## **Planning and Zoning Commission - Special Meeting AGENDA**

STAFF REPORT  
KETCHUM PLANNING AND ZONING COMMISSION  
SPECIAL MEETING OF FEBRUARY 23<sup>rd</sup>, 2021

- PROJECT:** Warm Springs Ranch
- FILE NUMBERS:** P 21-001, P21-002, P21-003, and P21-010
- APPLICATION TYPES:** Development and Rezoning Agreement, Large Block Preliminary Plat, Block 1 Subdivision Preliminary Plat, and Floodplain Development/Waterways Design Review

## L2 - Block 1 - Riparian Restoration Plan

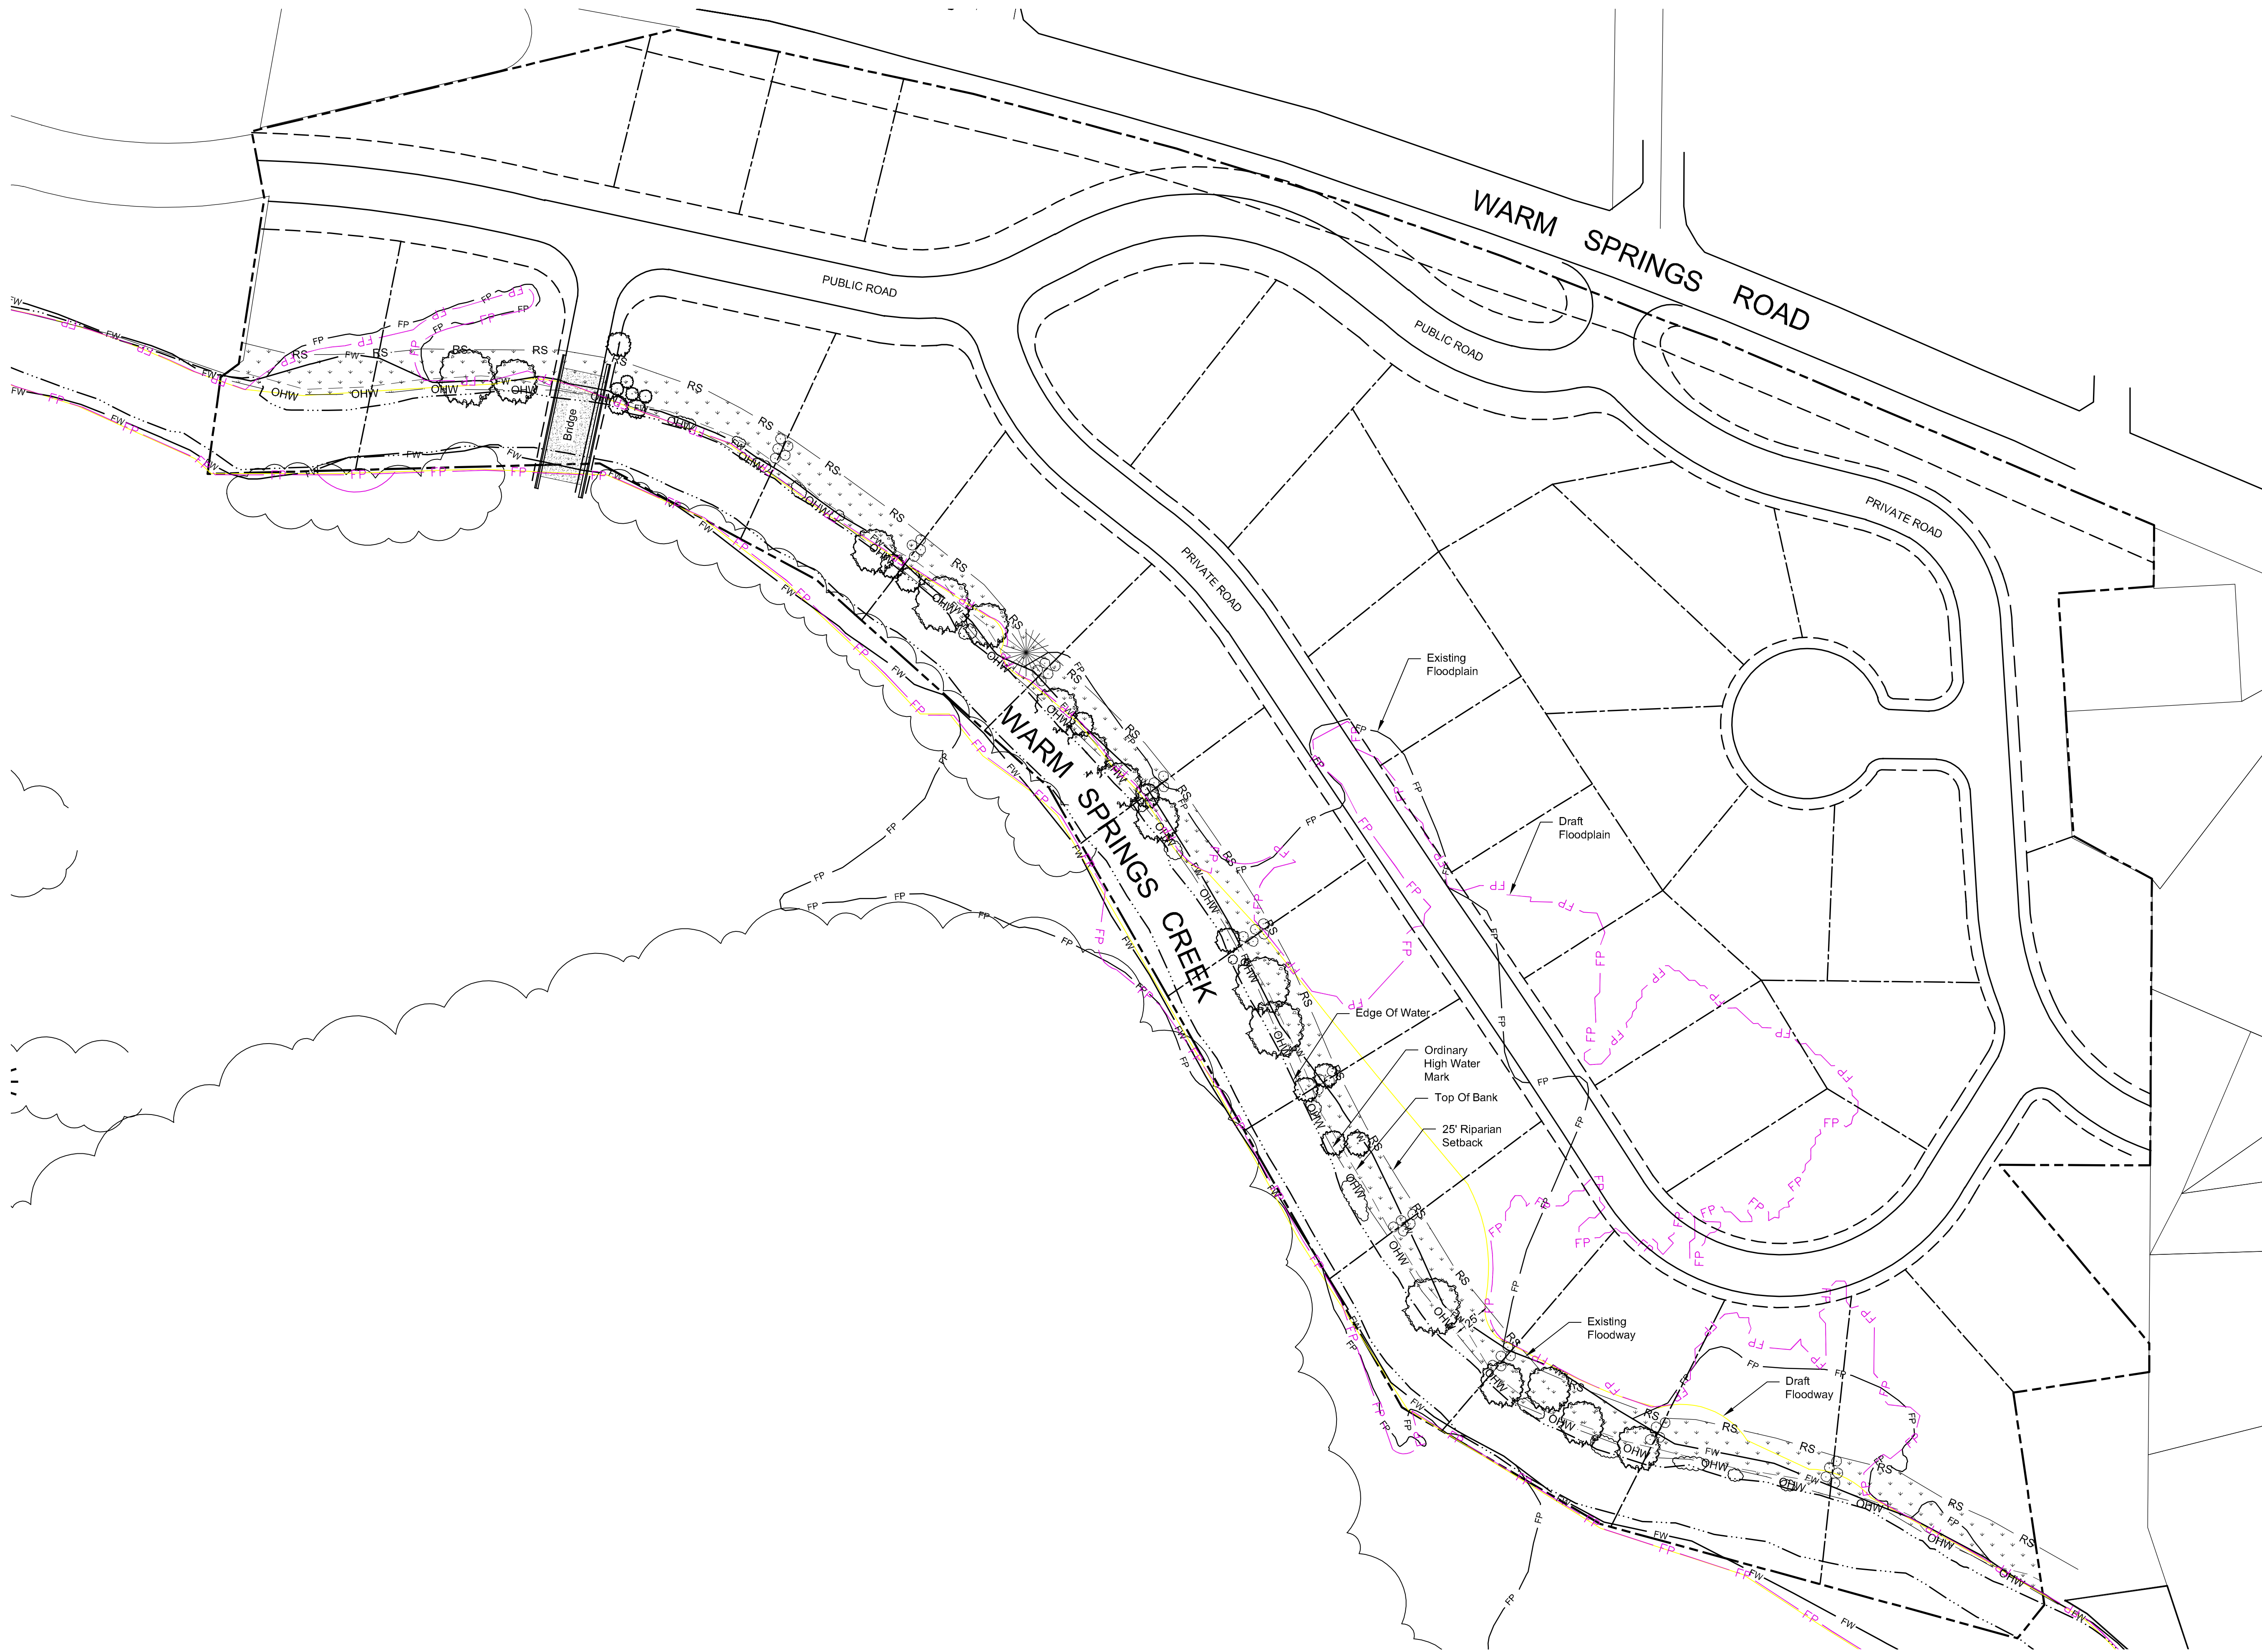
The riparian restoration plan, Sheet L2, includes the planting of 70 new 5-gallon size native shrubs (three species of willows, common snowberry, red-osier dogwood, and golden currant) and a native grass mix during the summer of 2021, the installation of temporary irrigation (for a maximum of two growing seasons) to aid in the vegetation's establishment, weed control (hand-

**C-2**

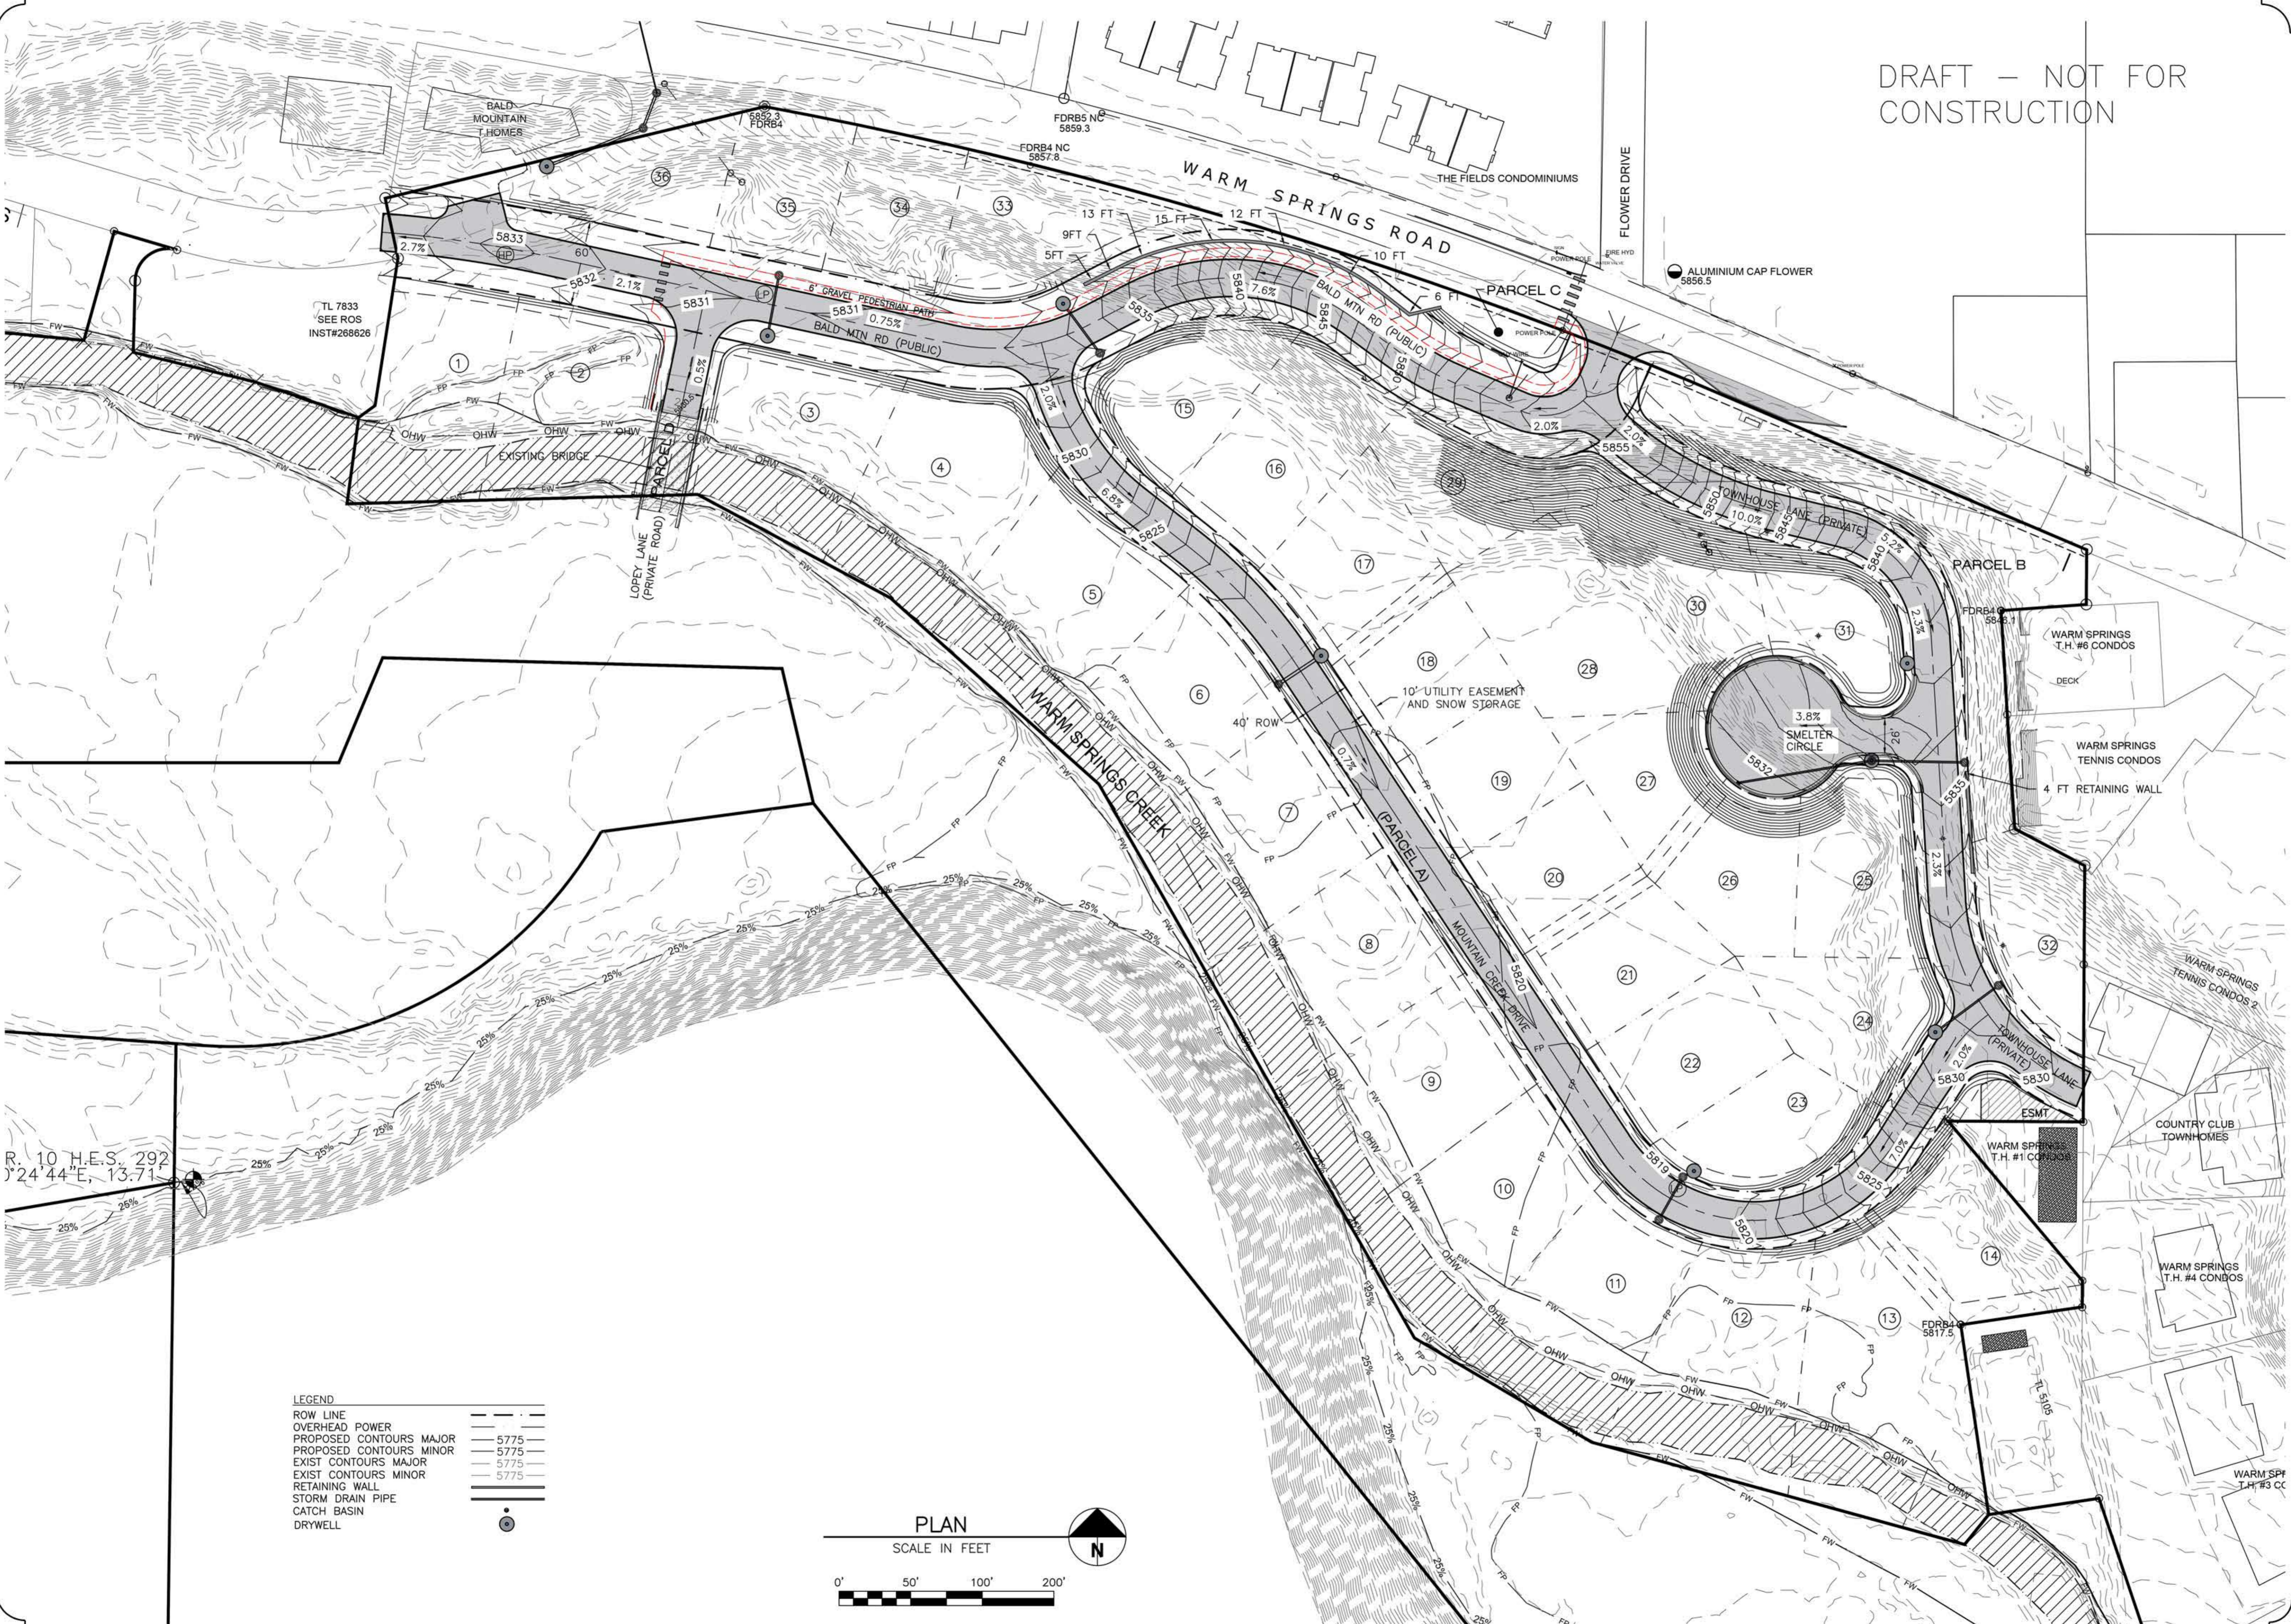
Drainage within the residential subdivision will be managed through a system of swales, catch basins, and drywells. The grading and drainage plan is indicated on Sheet C-2 of the project plans (Attachment C).

Staff Comments	<i>The grading and drainage plan is indicated on Sheet C-2 of the project plans. The proposed drainage plan is a system of drywells, catch basins, and storm drain pipes.</i>
<input checked="" type="checkbox"/>	<input type="checkbox"/>	<input type="checkbox"/>	16.04.030.J.15	<b>Vicinity map drawn to approximate scale showing the location of the proposed subdivision in reference to existing and/or proposed arterials and collector streets.</b>
			Staff Comments	<i>An area map showing Warm Springs Ranch Block 1 in relation to Warm Springs Road and existing Bald Mountain Road is included in the project plans.</i>
<input checked="" type="checkbox"/>	<input type="checkbox"/>	<input type="checkbox"/>	16.04.030.J.16	<b>The boundaries of the floodplain, floodway and avalanche overlay district shall also be clearly delineated and marked on the preliminary plat or a note provided if the entire project is in the floodplain, floodway or avalanche overlay district.</b>
